## Assessing new nuclear power station designs

Generic design assessment of Hitachi-GE Nuclear Energy Limited's UK Advanced Boiling Water Reactor

### Consultation document

12 December 2016

**Fig 9.5: Mean normalised annual gaseous carbon-14 discharges from BWRs 2005 – 2013. Pink line shows normalised UK ABWR estimated annual gaseous carbon-14 discharges.**

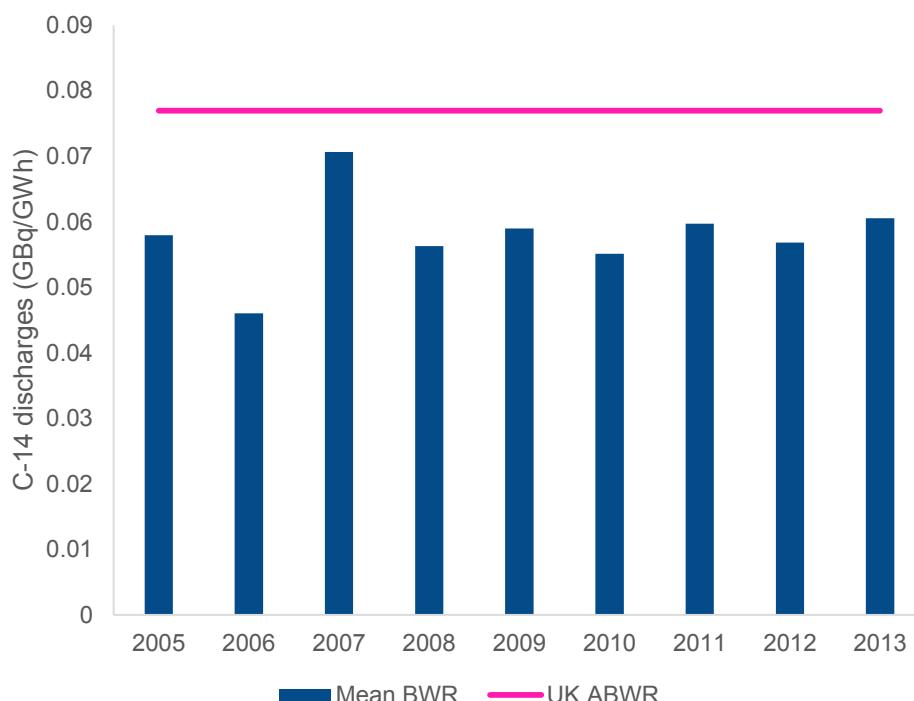
259. Annual gaseous carbon-14 discharges from BWRs range from 5.2E-03 to 1.1E-01 GBq/GWeh. The UK ABWR annual gaseous carbon-14 discharge is 7.7E-02 GBq/GWeh. Data are presented in Table 9.7 and Figure 9.5.

260. Estimated annual discharges of gaseous carbon-14 from the UK ABWR are higher than the mean annual discharges of gaseous carbon-14 from other operating BWRs but sit within the range of data obtained for operating BWRs. We are requesting further information on this matter and will consider the response when it has been submitted and report on it in our final decision document.
